# Modification of Development Consent

**Development consent:** **SSD-10452** granted by the Minister for Planning on 29 June 2021

**For the following:** Stubbo Solar Farm

**Modification:** **SSD-10452-Mod-1:** Minor changes to the internal access road location & project development area boundary adjustment

'Inset: Modification 1 Access road realignment'

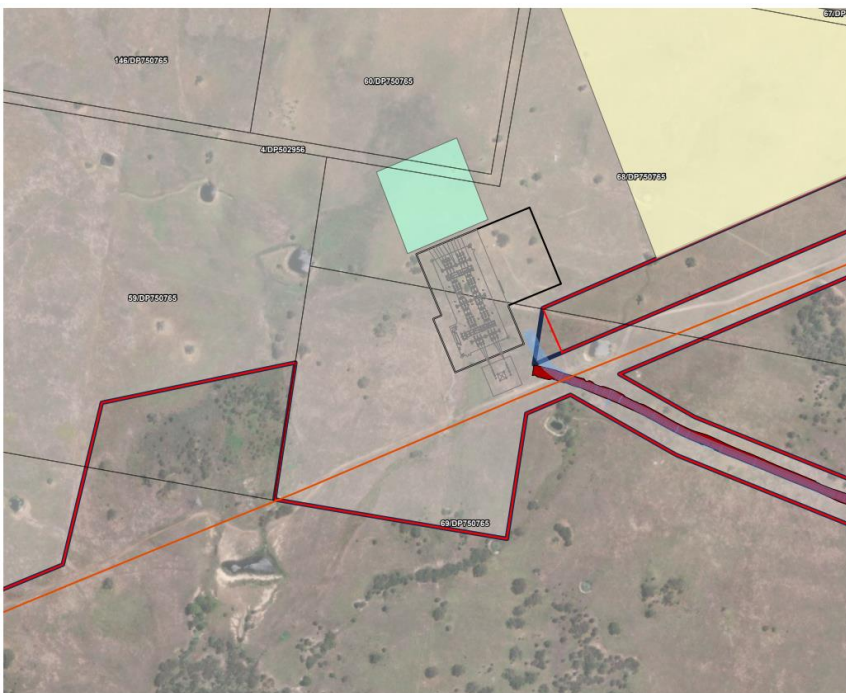
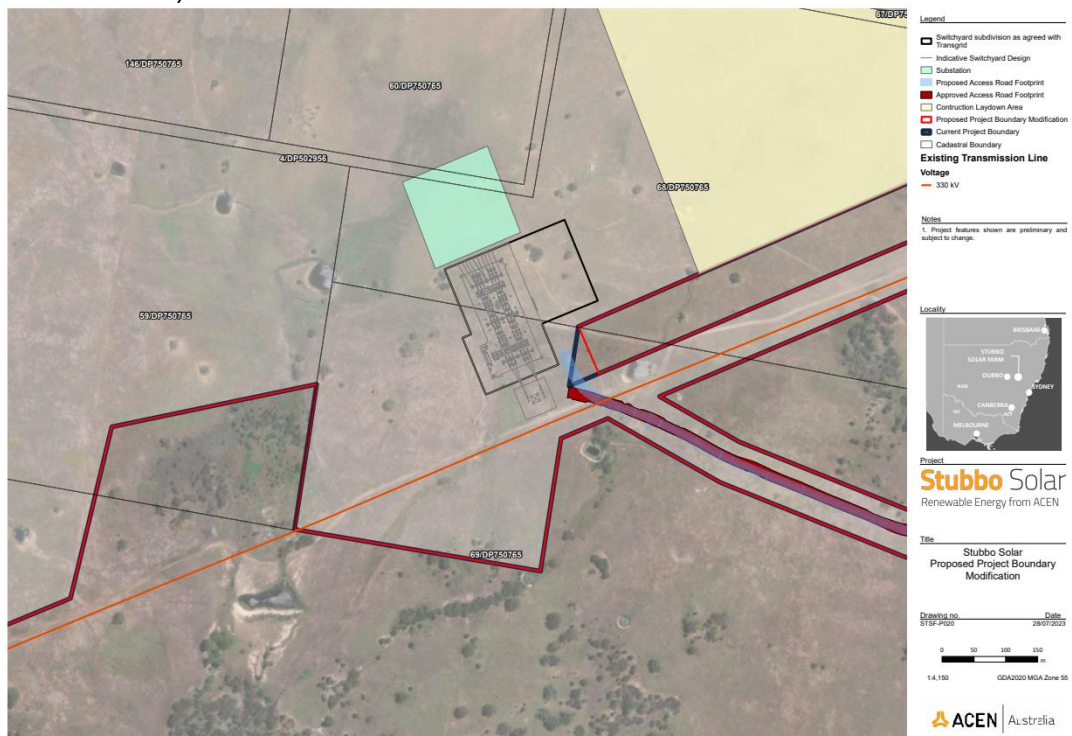
9. Delete the figure in Appendix 1 and replace with:
